VILLAGE OF WAYNE  
BUILDING AND DEPARTMENT  
PERMIT NOTES

PERMIT SCOPE: REMOVE AND REPLACE RESIDENTIAL ROOFING, GUTTERS AND DOWNSPOUTS

**THE PROJECT IS APPROVED AS SUBMITTED, SUBJECT TO:**

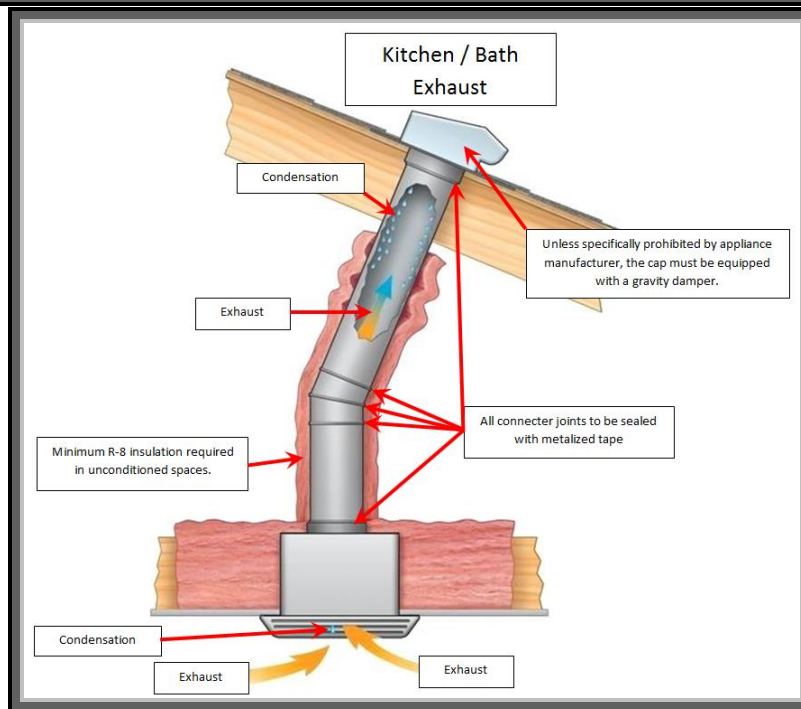
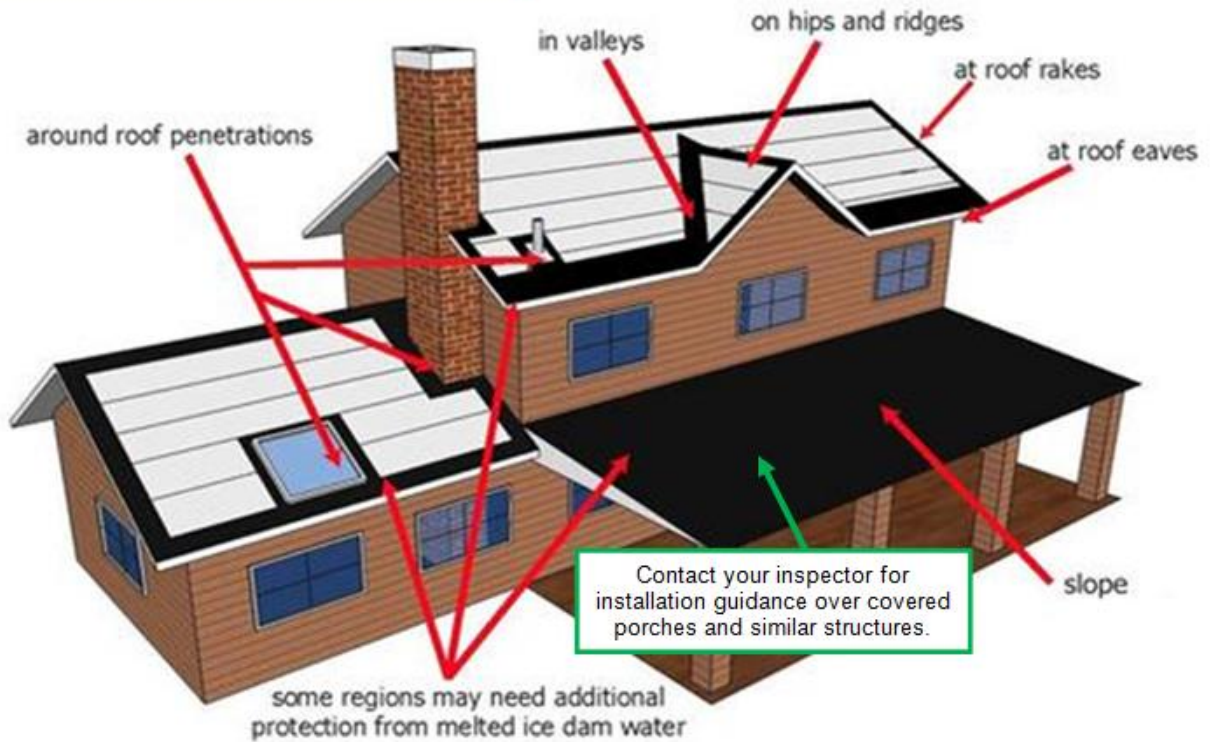
- 8.1 IT IS **RECOMMENDED** THAT EXISTING OR NEW KITCHEN OR BATHROOM VENTS TERMINATE TO EXTERIOR ON THEIR OWN TERMINATION WITH DAMPERS.
  - 8.2 "MUSHROOM"-STYLE VENT CAPS ARE NOT APPROVED FOR THIS PURPOSE.

- 8.3 SEE "EXAMPLE OF APPROVED KITCHEN AND BATHROOM VENT AND CAP," BELOW.
9. CONTRACTOR TO ENSURE SOFFIT VENTS ARE SIZED ADEQUATELY AND FREE OF DEBRIS, INSULATION, ETC.

### ICE BARRIER INSTALLATION ILLUSTRATION

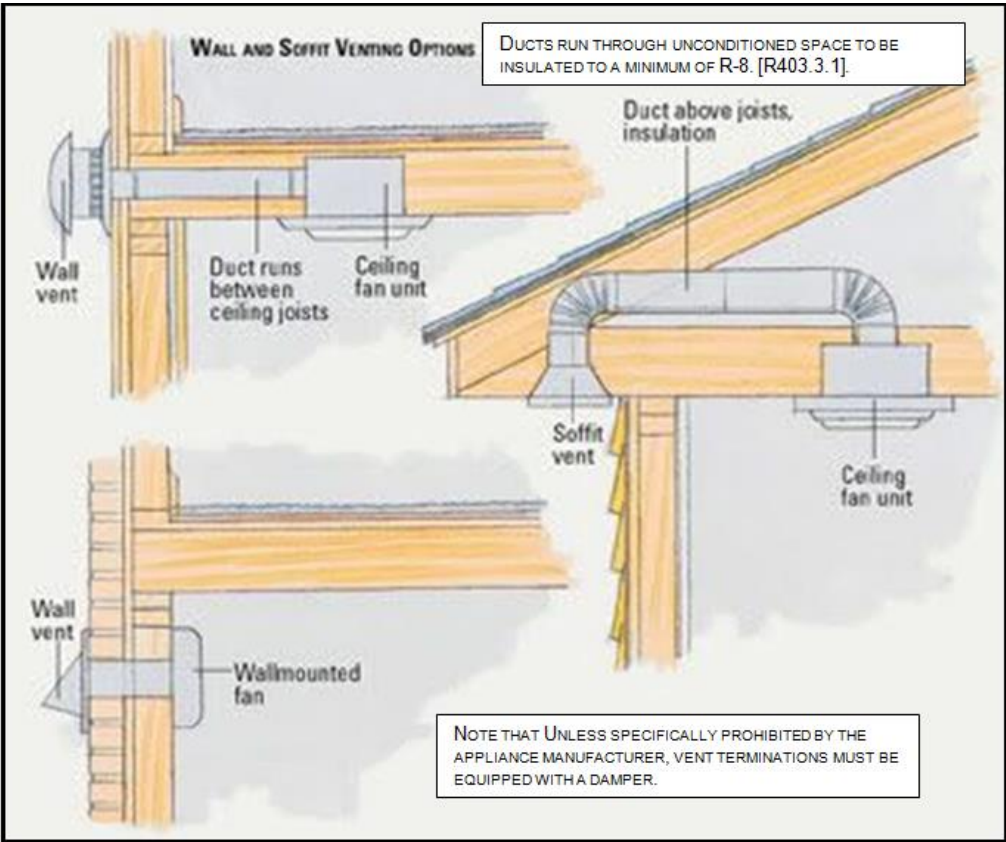
4. ROOF VENTILATION IS REQUIRED TO COMPLY WITH IRC [R806, R905, R908].
5. ROOFS SHALL COMPLY WITH ICE BARRIER REQUIREMENTS PER [R905.1.2] (SEE ILLUSTRATION BELOW.).

IRC [R905.1.2] REQUIRES ICE BARRIER INSTALLATION FROM THE LOWEST ROOF EDGE TO A **MINIMUM OF 24-INCHES** BEHIND THE EXTERIOR WALL LINE.

Roof drip edge

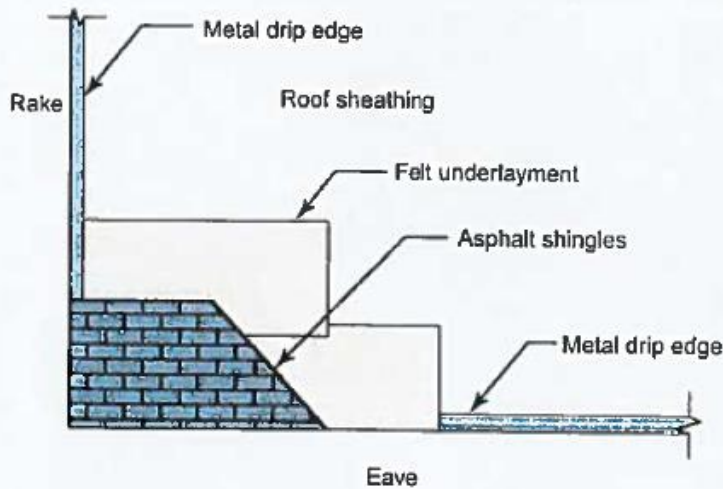
1. IF NOT MANDATED BY MANUFACTURER, IT IS RECOMMENDED THAT ICE BARRIER BE PLACED AROUND ALL PENETRATIONS.
6. ROOF DRIP EDGE IS REQUIRED AT EVE AND GABLE EDGES PER [R905.2.8.5] (SEE ILLUSTRATION RE: IRC 905.2.8.5, BELOW.).

**2012 CODE: R905.2.8.5 Drip Edge.** A drip edge shall be provided at eaves and gables of shingle roofs. Adjacent pieces of drip edge shall be overlapped a minimum of 2 inches (51 mm). Drip edges shall extend a minimum of 0.25 inch (6.4 mm) below the roof sheathing and extend up the roof deck a minimum of 2 inches (51 mm). Drip edges shall be mechanically fastened to the roof deck at a maximum of 12 inches (305 mm) on center with fasteners as specified in Section R905.2.5. Underlayment shall be installed over the drip edge along eaves and under the drip edge on gables. Unless specified differently by the shingle manufacturer, shingles are permitted to be flush with the drip edge.
